## Application for Works Approval

<b>Works Approval Number</b>	W6821/2023/1
<b>Applicant</b>	Tyrecycle Pty Ltd
<b>ACN</b>	085 545 053
<b>File number</b>	DER2023/000376
<b>Premises</b>	Tyrecycle Wedgefield 22 Moorambine Street WEDGEFIELD WA 6721  Legal description - Lot 100 on Deposited Plan 61456 As defined by the coordinates in Schedule 1 of the works approval
<b>Date of report</b>	18 January 2024
<b>Decision</b>	Works approval granted

**Figure 3: Extent of inundation of the premises with contaminated firewater**

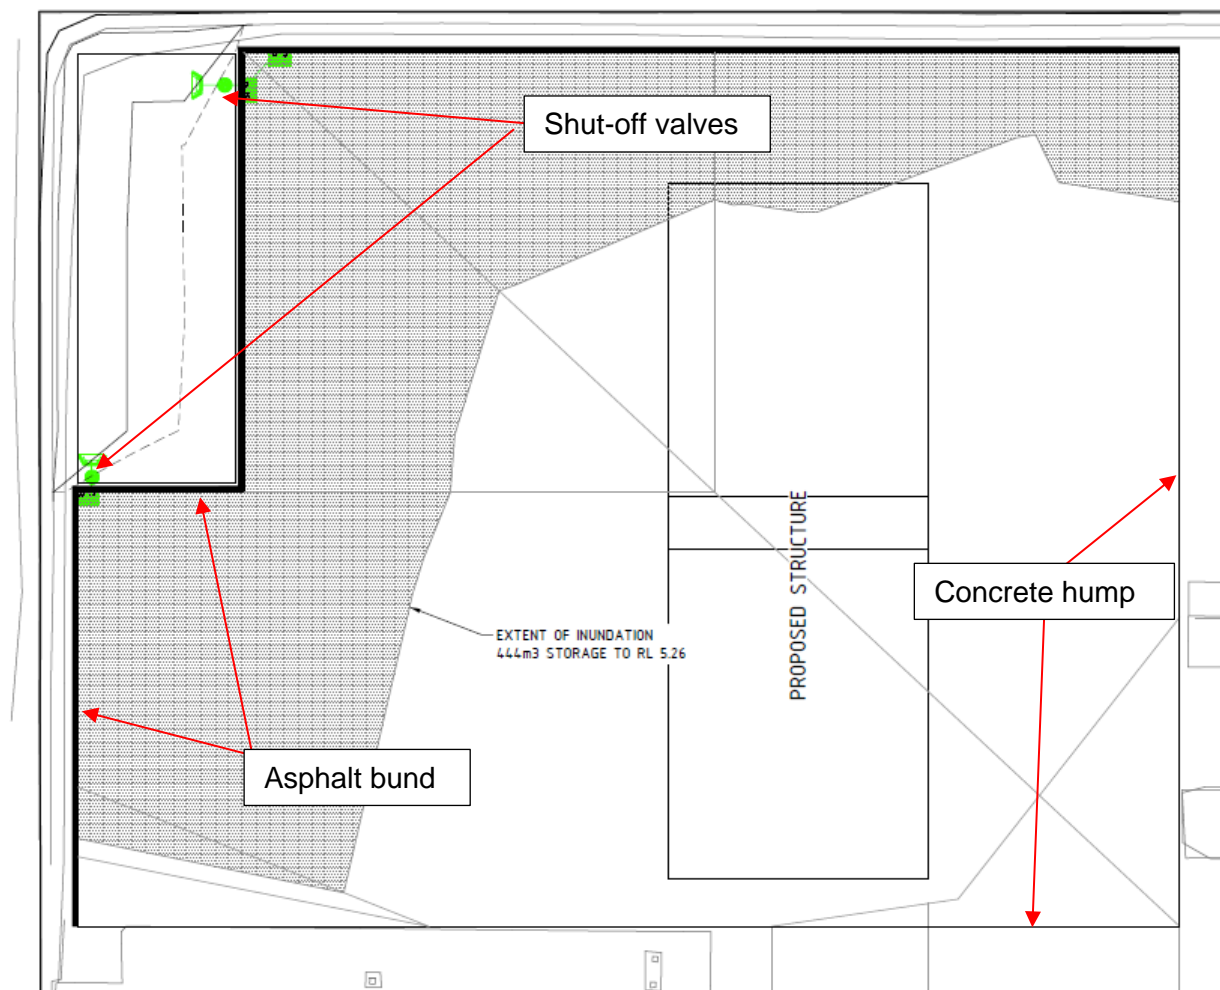
The extent of the hardstand area within the premises that will be inundated by firewater is outlined in Figure 3 below.

An asphalt bund wall will be installed along the northern and western boundary of the hardstand area. The asphalt bund shall be impermeable to  $\leq 1 \times 10^{-9}$  m/sec and built to ensure the 432,000 litres of firewater is retained within the impermeable hardstand area. This bund will be located in front of the swale walls and act as a barrier to prevent firewater from coming into contact with the stormwater swale walls.

Stormwater drains will connect the inundation zone within the hardstand area to the swales and will remain open during normal operation to allow stormwater to exit via gravity feed out of the hardstand area into the swales for disposal.

Electronic shut-off valves will be fitted to the stormwater drains that will automatically close during fire events to isolate the stormwater drainage lines and prevent firewater entering the stormwater swales located along the north and western boundary of the premises. The electronic shut-off valves will be controlled by the electronic fire detection system that will be installed as part of the development of this facility.

Further a concrete hump will be constructed along the eastern and southern boundaries of the hardstand area; and will act as a bund to contain the firewater and prevent offsite movement to the neighbouring premises. This hump will not contain any shut-off valves as the sole purpose is to prevent off-site movement of stormwater and firewater.
